PROJECT: Area 15 Event Parking Lot

CITY OF LAS VEGAS		DATE:
INTER-OFFICE MEMORANDUM		July 22, 2020
TO: Land Development Services Department of Building & Safety		FROM: Albert Sung, P.E. Flood Control Project Engineer Department of Public Works
SUBJECT:	Drainage Study for:	
	Area 15 Event Parking Lot	
Cross Streets:	NWC of Rancho Drive & Sirius Avenue	
File Number:	F:\Depot\DSMemos\DS5288B.doc	
Parcel Number:	162-08-702-002	
Zoning Action:	SDR-78709 & VAR-78074	
FEMA Flood Zone	YES	NO X
Proposed Storm Drain	YES	NO X
COPIES TO:		Kimley-Horn and Associates, Inc.
		Area 15 Las Vegas, LLC
		Bart Anderson, P.E., DevCo
		CCRFCD
		NDOT

**Addendum to the
Technical Drainage Study
for**

Area 15 Event Parking Lot

- LID Parking Lot LID Map & Calculations
- Table 505 2-Year 6-Hour Rainfall Depth-Duration-Frequency (McCarran)

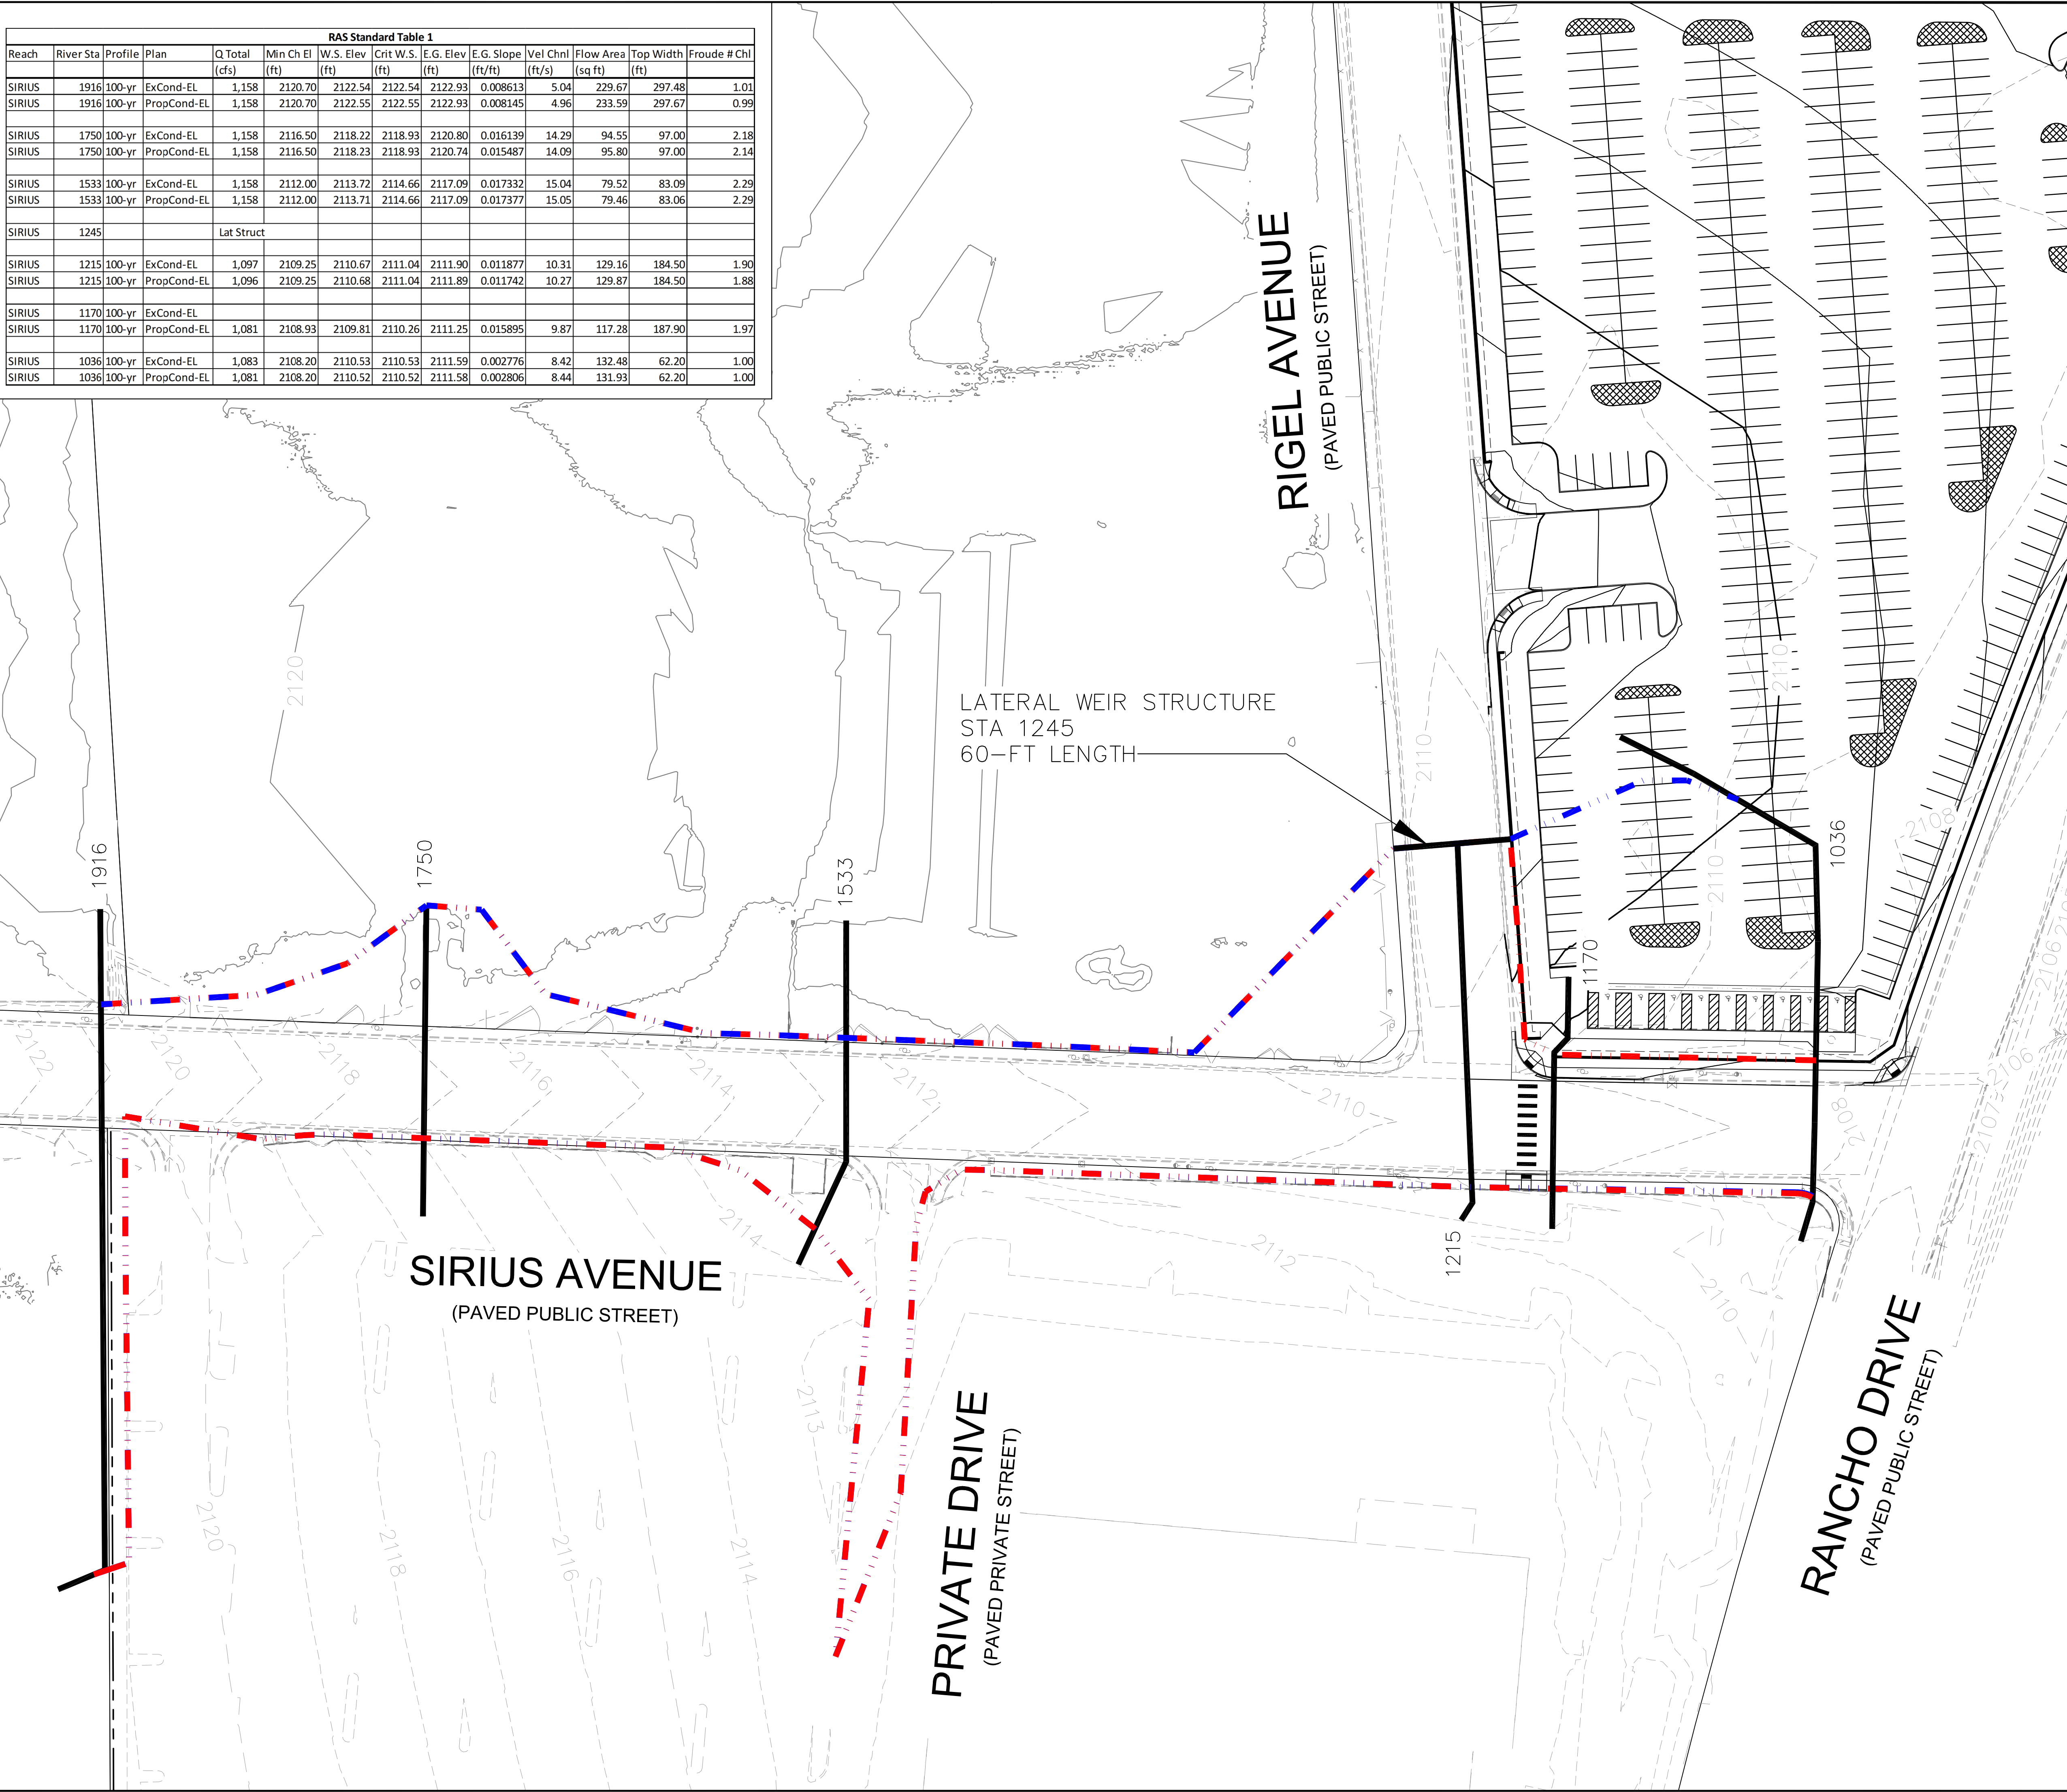
6. The overall parking lot improvement area is larger than 1 acre. Per **Section 1500** of the *Clark County Regional Flood Control District's Hydrologic Criteria and Drainage Design Manual*, the subject improvements must provide for Low Impact Development (LID) measures. Review and address the issue in the next submittal.

Comment 6: The overall parking lot improvement area is larger than 1 acre. Per Section 1500 of the Clark County Regional Flood Control District's Hydrologic Criteria and Drainage Design Manual, the subject improvements must provide for Low Impact Development (LID) measures. Review and address the issue in the next submittal.

Response: Per Section 1502.2 of the CCRFCD "Hydrologic Criteria and Drainage Design Manual", this project is categorized as a **Large Parking Lot** since the size of the on-site parking lot is approximately **+/-3.5 acres**.

For the Large parking lot category, BMPs are required to treat storm water runoff from at least 75 percent of the parking lot. BMPs are sized for the 85th Percentile Rainfall. Please refer to Appendix D for all LID calculations and for **Figure LID – LID Basin Map**.

The proposed **LID Basin Map** and QBMP calculations are included in **Appendix C**. The proposed BMPs are shown on the grading plan included in **Appendix D**.

GRADING PLAN

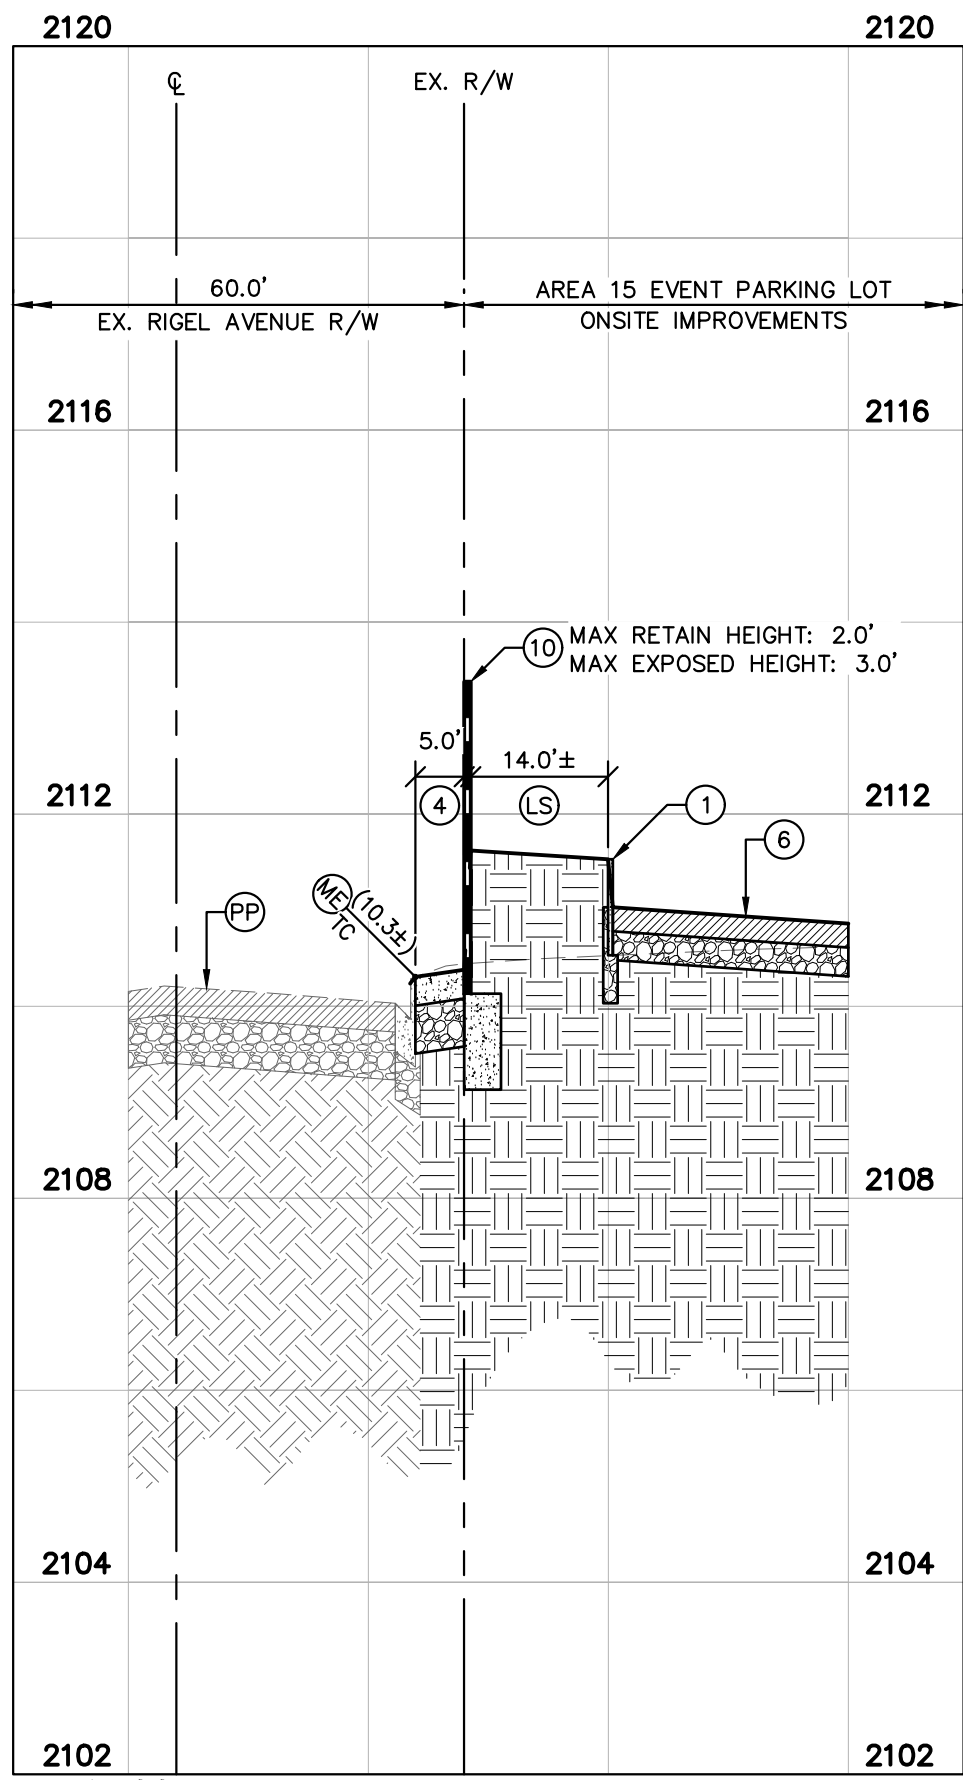
5. **Sheet C3.01:** Identify an existing storm drain "I15 050" located at the center portion of the subject site running across the site to the *Rancho* channel. Address what need to be done to this facility, to be removed, buried in place or provide a catch basin to utilize it or something?

Comment 5: Sheet C3-01: Identify an existing storm drain “I15 050” located at the center portion of the subject site running across the site to the Rancho channel. Address what needs to be done to this facility, to be removed, buried in place or provide a catch basin to utilize it or something?

Response: Facility I15 050 is identified as a 48” RCP per the *Central Neighborhood Flood Control Master Plan Study for City of Las Vegas* (Neighborhood Master Study) at the northern limits of the project site referencing CLV Plan #327-V221. The referenced plan correlates to facilities along Meade Avenue which are not adjacent to the project site. Additionally, a site visit confirmed no such facility exists or connects to the existing NDOT drainage facility adjacent to Rancho Drive and I-15. Therefore, it is not shown on our plans and no drainage recommendations are proposed for connection.

FIGURE
RAS-1

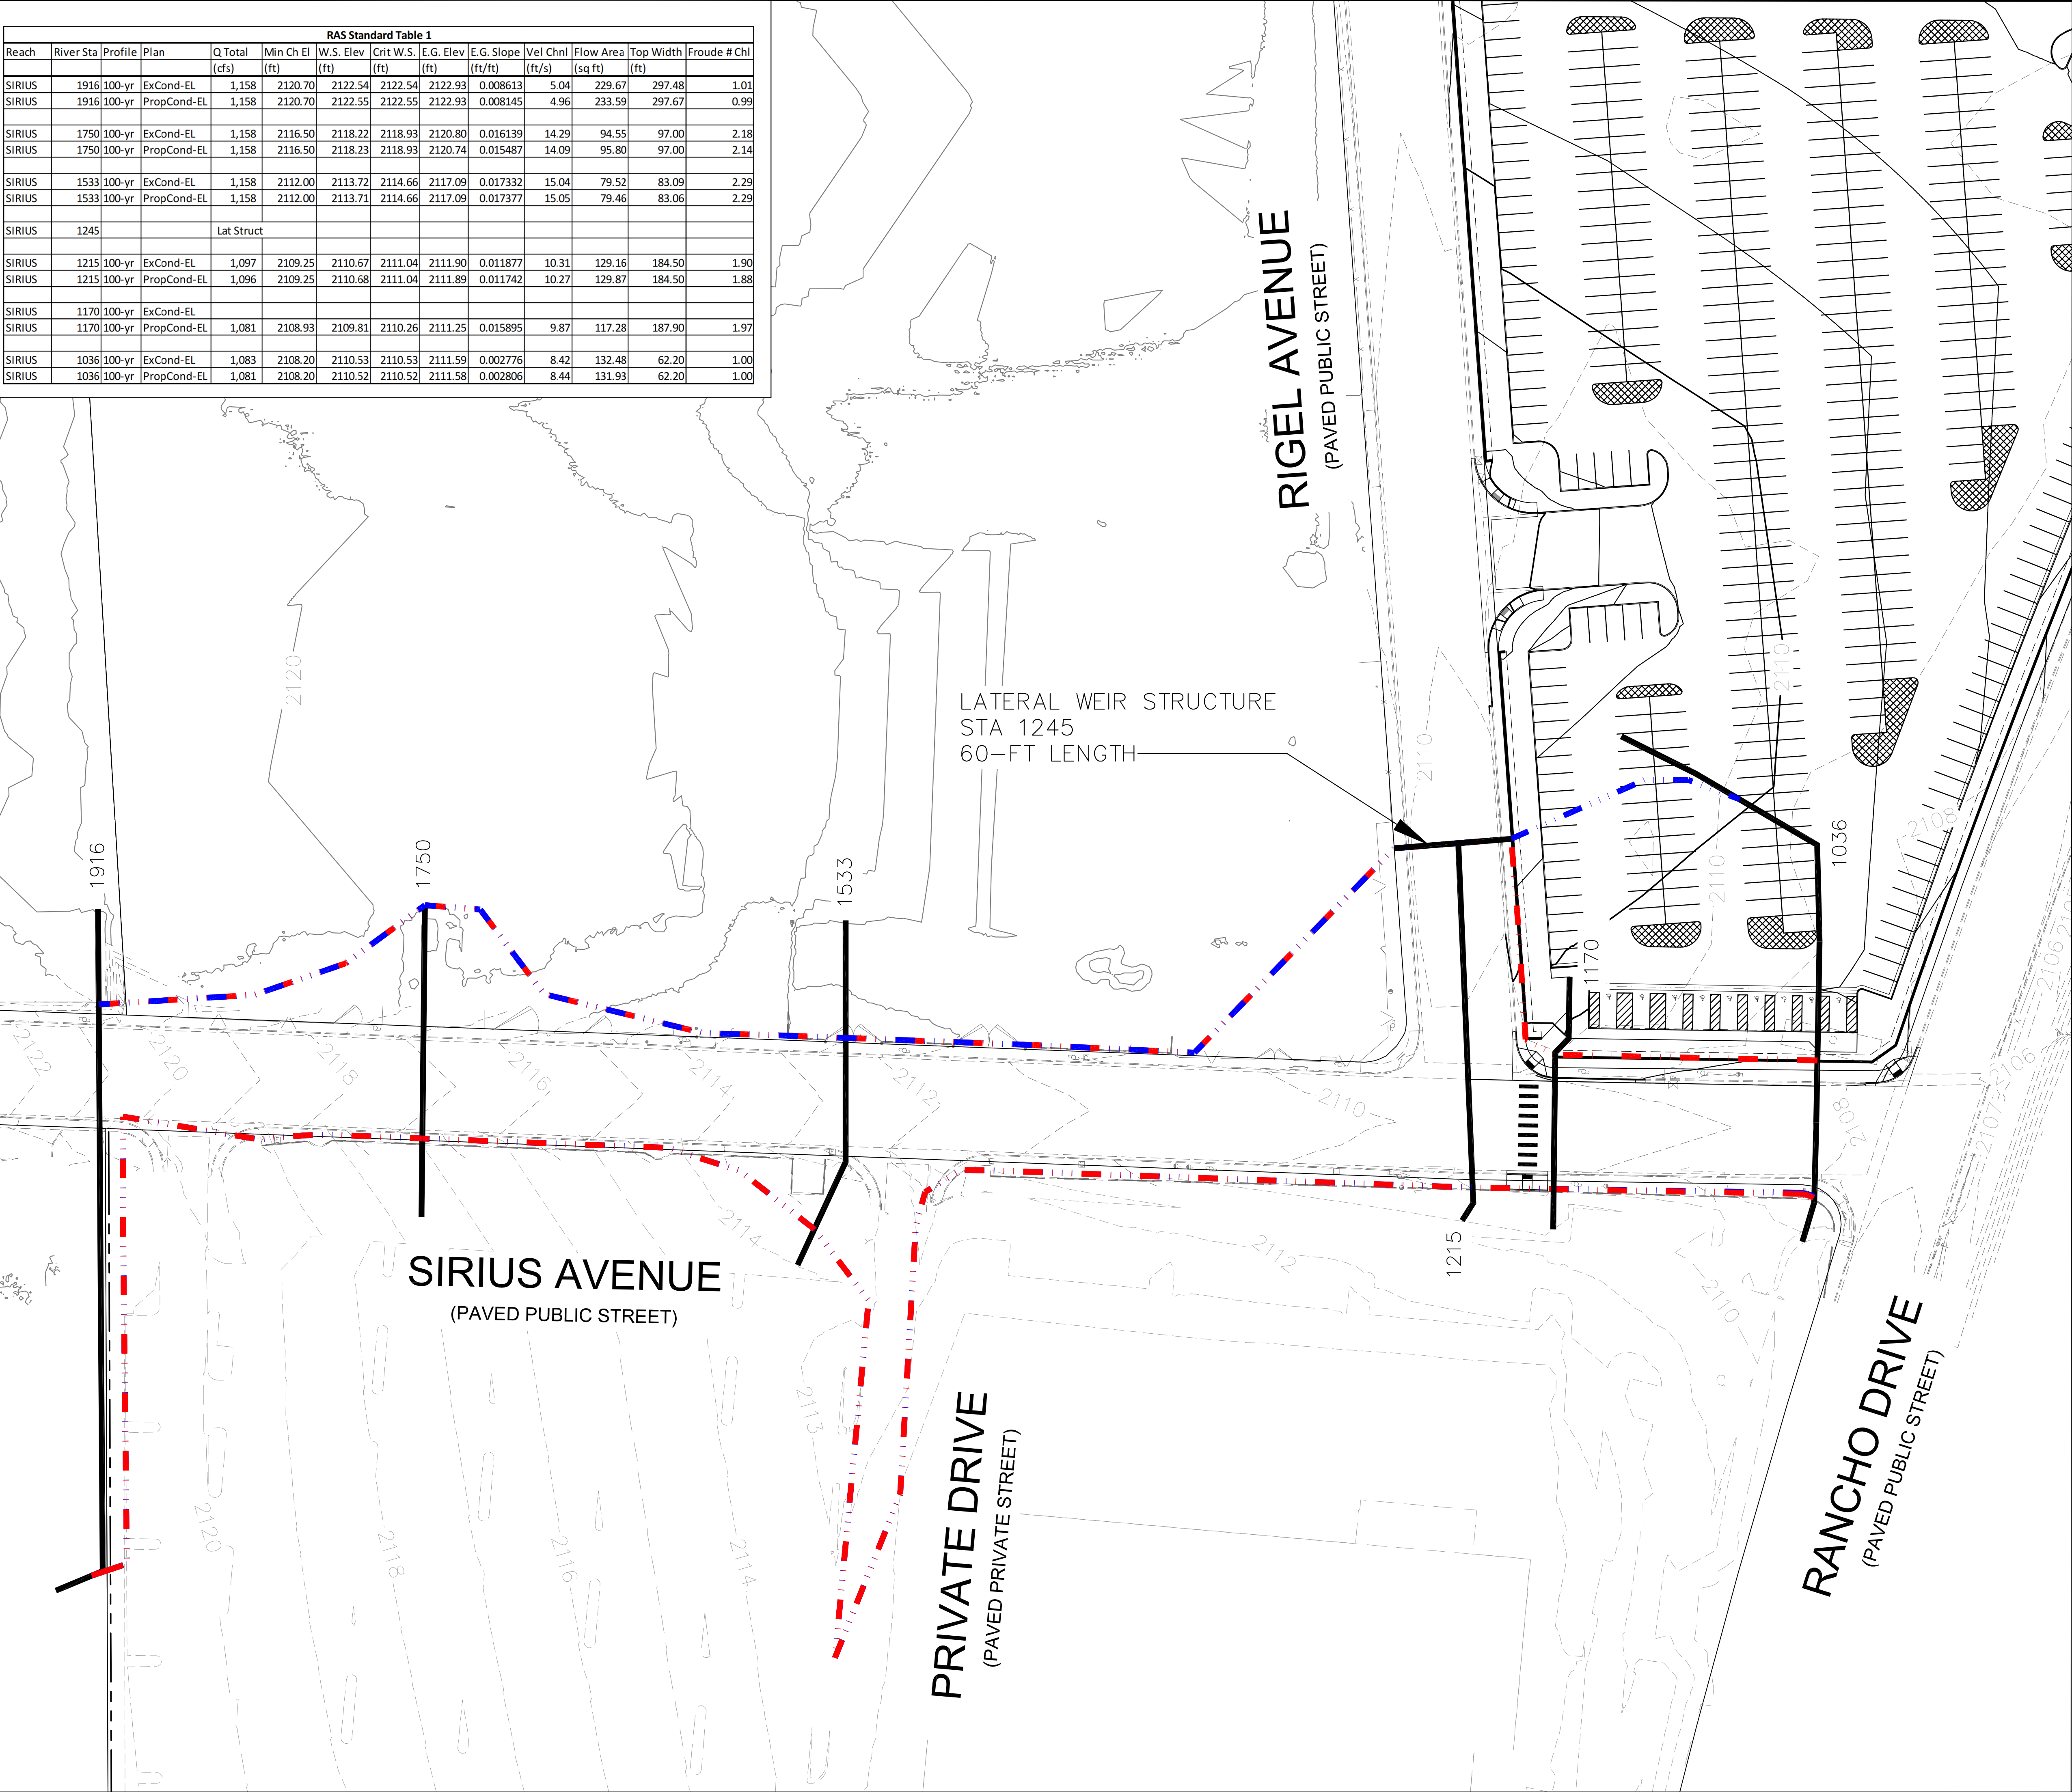
4. **Figure RAS-1:** There are two river station labeled at the same value of "1036". It is obvious that the "River Station 1036" identified at the intersection of *Sirius Avenue* and *Rigel Avenue* should be River Station **1170**. Review and revise accordingly in the next submittal.

Comment 4: Figure RAS-1: There are two river station labeled at the same value of “1036”. It is obvious that the “River Station 1036” identified at the intersection of Sirius Avenue and Rigel Avenue should be a River Station 1170. Review and revise accordingly in the next submittal.

Response: The RAS River **Station 1170** has been correctly labeled on **Figure RAS-1** in **Appendix A**. Note that the HEC-RAS model remains unchanged with this submittal.
